February 28, 1968

CONTRACT WTC-221.00
WORLD TRADE CENTER
THE PORT OF NEW YORK AUTHORITY
LACLEDE CONTRACT 67-J-31801

MEMORANDUM NO. 11

CONTRACT WTC-221.00
WORLD TRADE CENTER
THE PORT OF NEW YORK AUTHORITY
LACLEDE CONTRACT 67-J-31801

LACLEDE STEEL COMPANY ST. LOUIS, MISSOURI	CLASS: Standards — Steel Truss	DATE 3-1-67
Steel Truss Angle Sections		REV. 1-15-68
(Special Angles Type 15, 16, 17)		FILE 2-24-68
ENGINEERING DEPARTMENT J.R.P. APPROVED R.D.B.		DRAWING F3-r-302

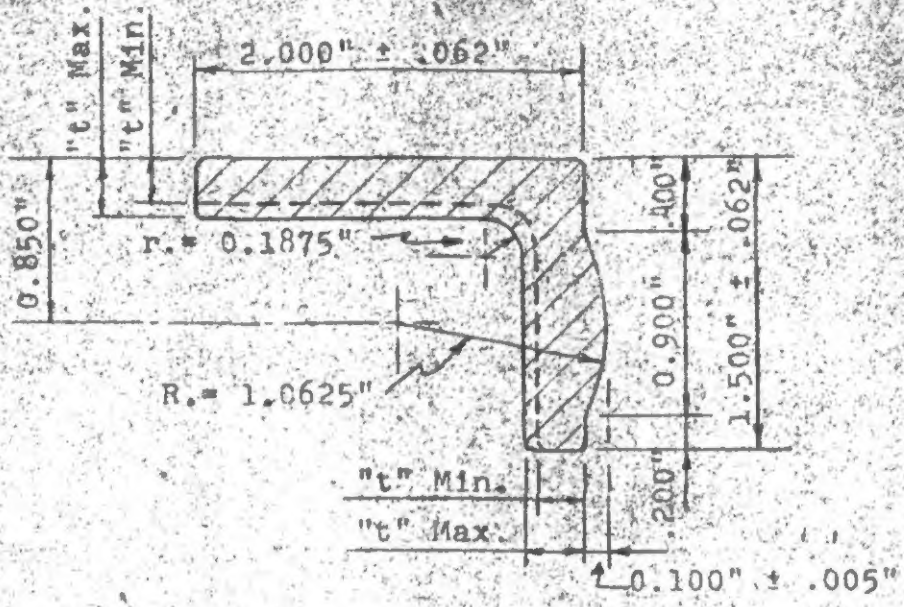
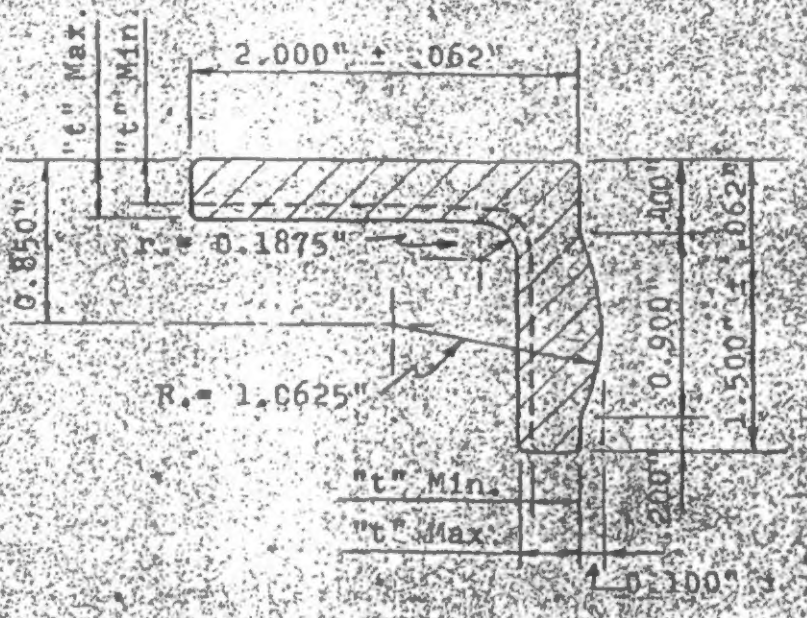
F3-r-302 was changed to show a new angle type 17 which is a 2" x 1-1/2" x .370 Angle.
F3-4-305 was revised to change the tolerance shown on the 3" leg.

DRAWING F3-r-308 DATE 1-24-68 REV. FILE

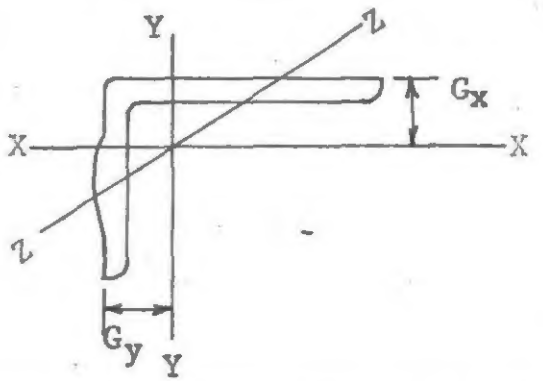
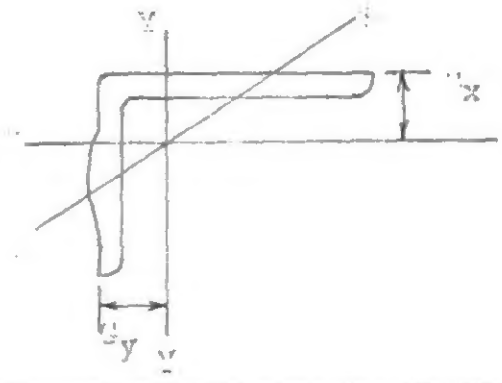
Drawing F3-4-308 shows the design properties of ~~all~~ bulb-legged angles used on the project.
